RESPONSE OF VERIZON PENNSYLVANIA INC. TO DATA REQUEST NO. 1, DATED
OCTOBER 2, 2003, SUBMITTED IN DOCKET M-00031754 BEFORE THE PA PUC
(Development of an Efficient Loop Migration Process)

RESPONSE OF VERIZON PENNSYLVANIA INC. TO DATA REQUEST NO. 2, DATED OCTOBER 2, 2003, SUBMITTED IN DOCKET M-00031754 BEFORE THE PA PUC (Development of an Efficient Loop Migration Process)

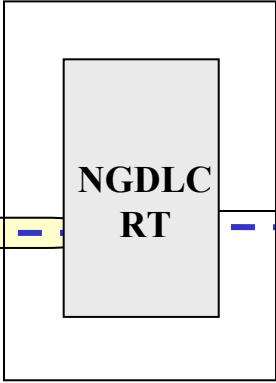
If the tasks related to the hot cut process for lines served using integrated digital line carriers differs from the process used for other lines, discuss how the process is different and list the tasks that must be added specifically for the lines served using integrated digital line carriers. Include the time required to accomplish those tasks, the labor cost and loaded labor cost associated with those tasks.

There is no technically feasible, practicable means of obtaining access to the individual voice-grade loops when provisioned over an IDLC system. Accordingly, before a customer served by an IDLC-equipped loop can be cut over to a switch-based CLEC, the customer must be shifted from an IDLC-equipped loop to an all-copper loop or to a loop served via Universal Digital Loop Carrier ("UDLC") technology.

In the case of IDLC-equipped loops, a technician must be dispatched to the Serving Area Interface ("SAI") associated with the copper distribution pair that serves the customer. (Because the SAI is part of the outside loop plant, such dispatches are referred to as "outside" dispatches.) In order to permit a hot cut to be made, the distribution pair must be moved at the SAI so that it will be cross-connected either to a pair in a copper feeder system, or to a sub-feeder pair associated with a UDLC system in the RT.

1. The customer must be shifted from an IDLC-equipped loop to an all-copper loop or to a loop served via UDLC prior to the cut requiring an outside dispatch
2. On IDLC cuts, the frame technician will wire the CLEC dial tone to the alternative facility identified by the Assignment Provisioning Center (APC). The final cutover will then take place in the field at the SAI.

Outside Dispatch required to move copper distribution pair connection at SAI from existing IDLC pair count to either an UDLC pair count or copper feeder pair from C.O.
